Re: Comments on ICC ES Hearing Subject AC377-0609-R2 (SF/MB)

Subject: SPFA Comments on Proposed Modification to ICC AC-377 dated April 30, 2009

SPFA Comments to AC 377

SUBJECT: Proposed Revisions to the Acceptance Criteria for Spray-applied Foam Plastic Insulation, Subject AC377-0609-R2 (SF/MB)

Figure 1 (revised 5-11-09)

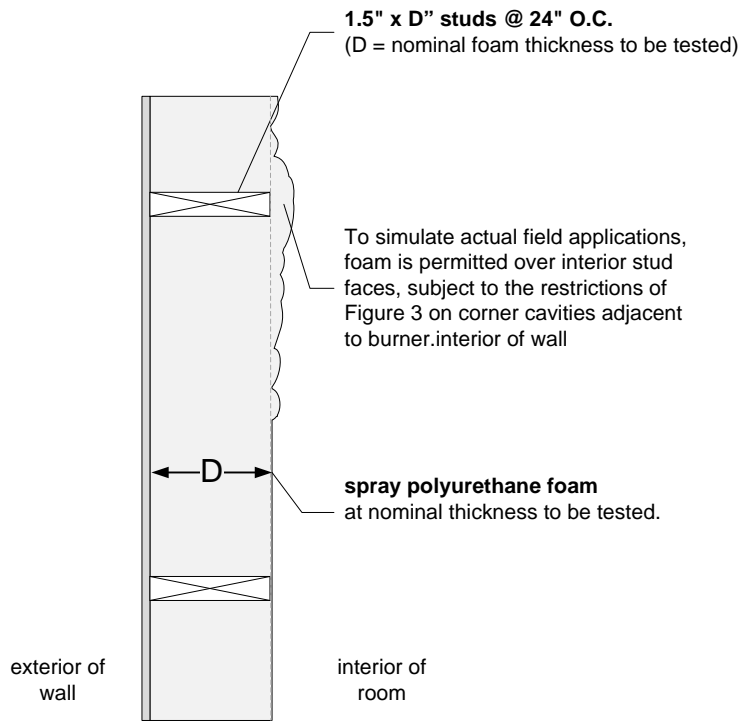
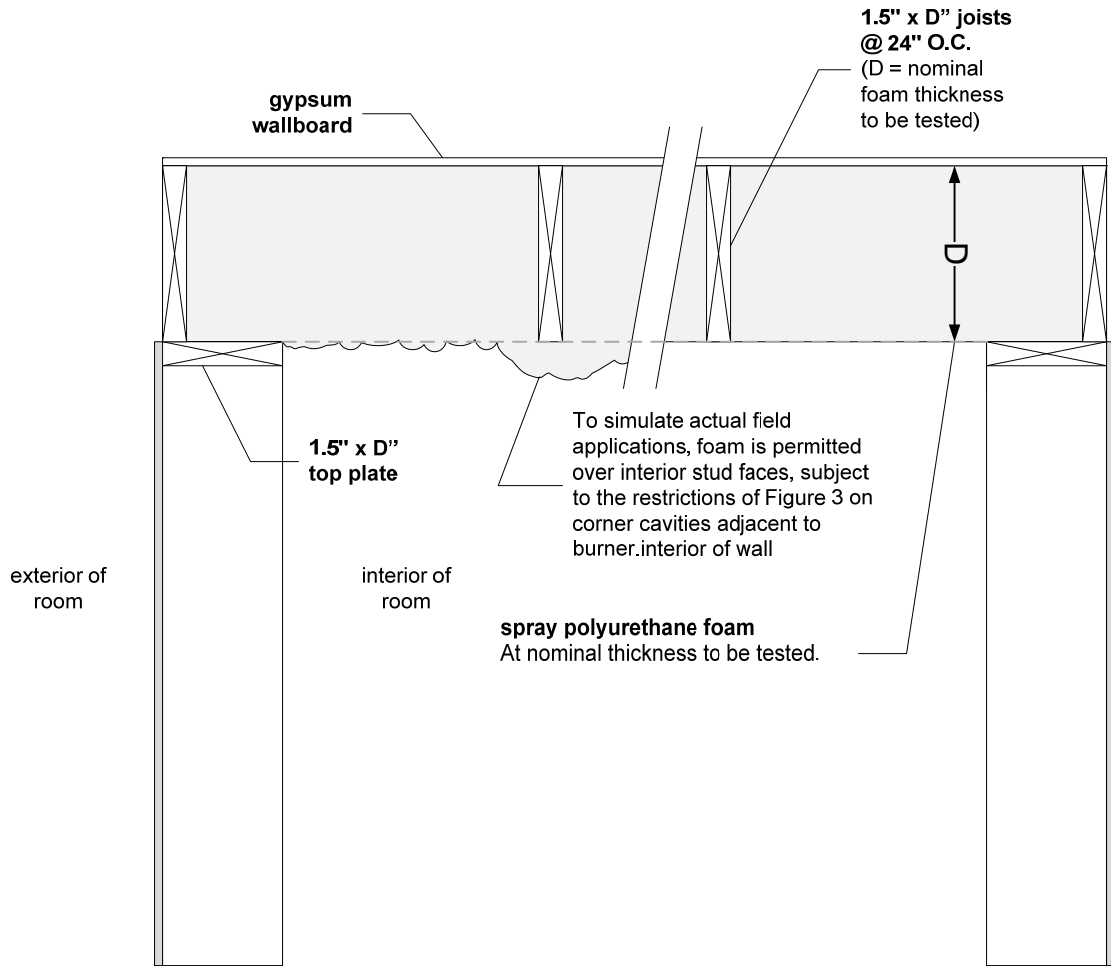
This document suggests 16 itemized revisions, along with supporting rationale for each change. In addition, it provides two updated figures to better define the foam surface profile and thickness measurement for the test module.

Comment – Appendix X – use revised Figures 1 and 2 that are attached.

Reason – Clarifies actual dimension of lumber.
